# Product Change Notification

PCN#21-17 Add process holes on RB series detect switches

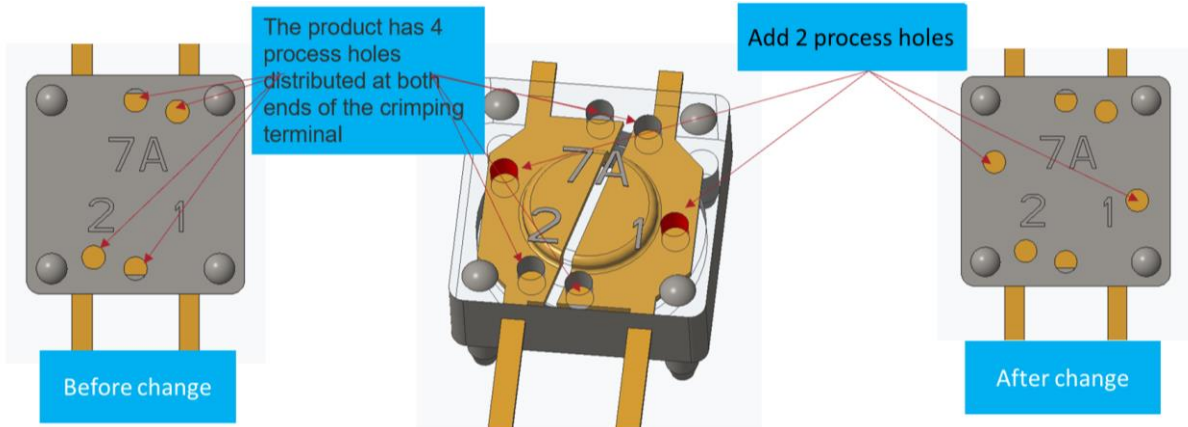
Add 2 process holes to improve the injection molding :

Add 2 process holes only, no functional change to this product.
